<b>Illinois Tollway Base Sheet Revisions</b>
--

<b>Section M</b>		<b>Base Sheet Drawings</b>	
<b>Drawing</b>	<b>Modification Summary</b>	<b>Effective: 03-01-2024</b>	
<b>Flashing Sign Beacon (ITS)-Series 1700</b>			
<b>M-ITS-1700</b>	<b>Flashing Sign Beacon Installation Breakaway Electrical Detail</b>		
	Added new detail for Ramp Queue Warning Sign with installation details and layout		
<b>M-ITS-1701</b>	<b>Cabinet Layout and Wiring ITS Pole Mounted Enclosure (1-CCTV and Flashing Sign Beacon)</b>		
	Added detail of breaker assembly showing solid line around breaker that represents the cut through the Plexiglas protected cover

**CABINET LAYOUT AND WIRING ITS POLE MOUNTED ENCLOSURE (1-CCTV AND FLASHING SIGN BEACON)**

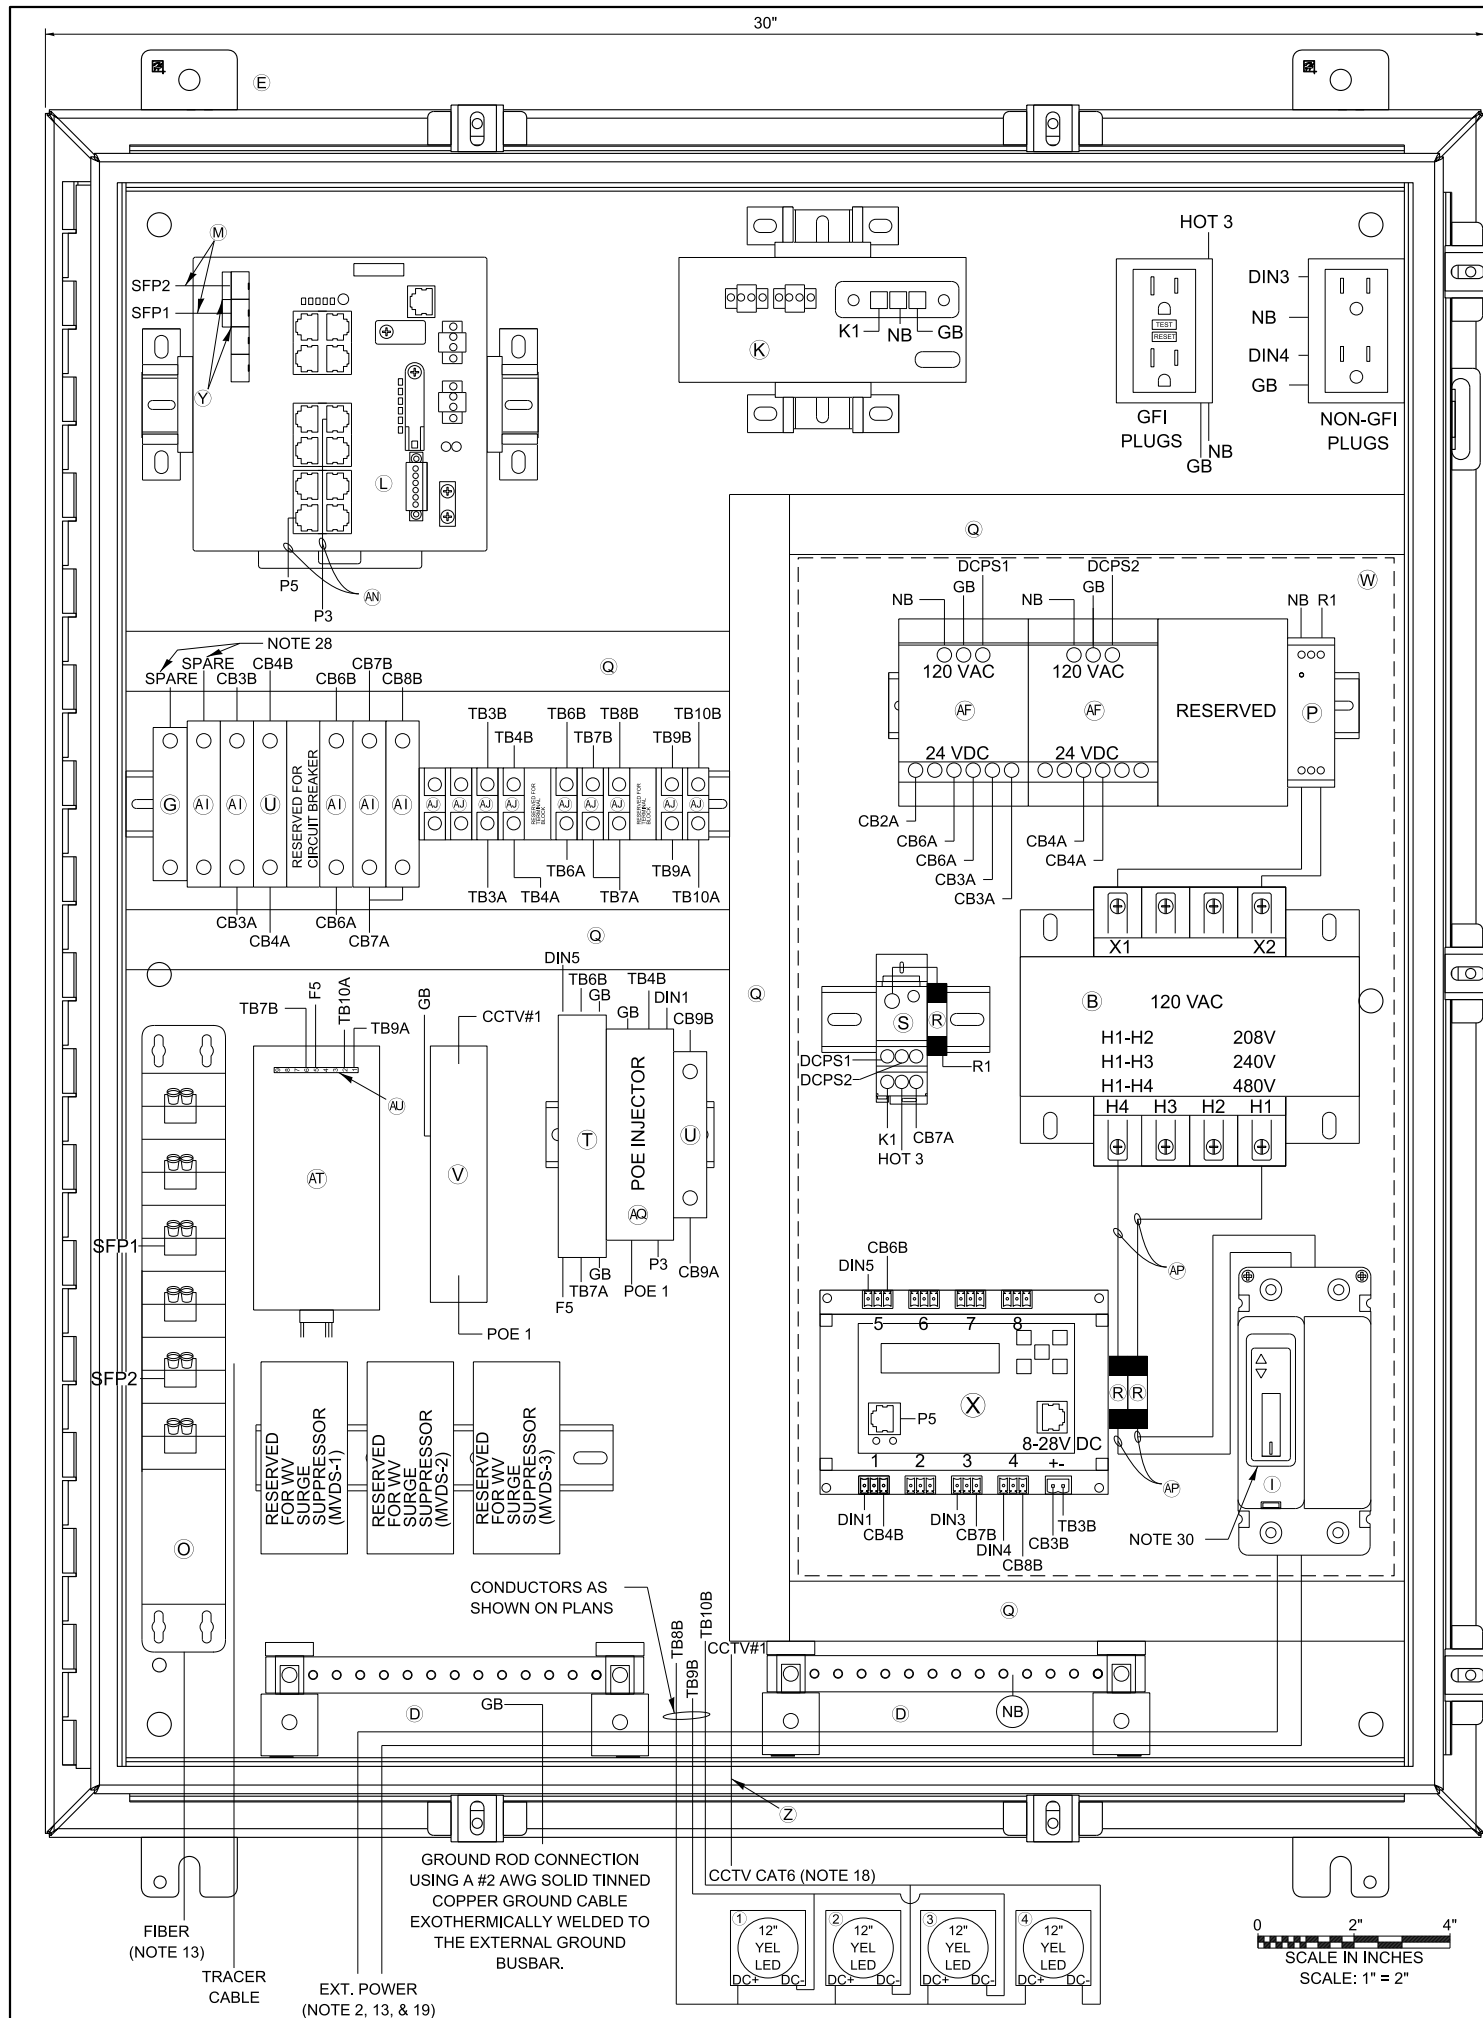
- PROVIDE WINDOW IN PMMA SHIELD FOR ACCESS TO BREAKER. MOUNT BREAKER FLUSH WITH PMMA SHIELD USING MOUNTING BRACKET.
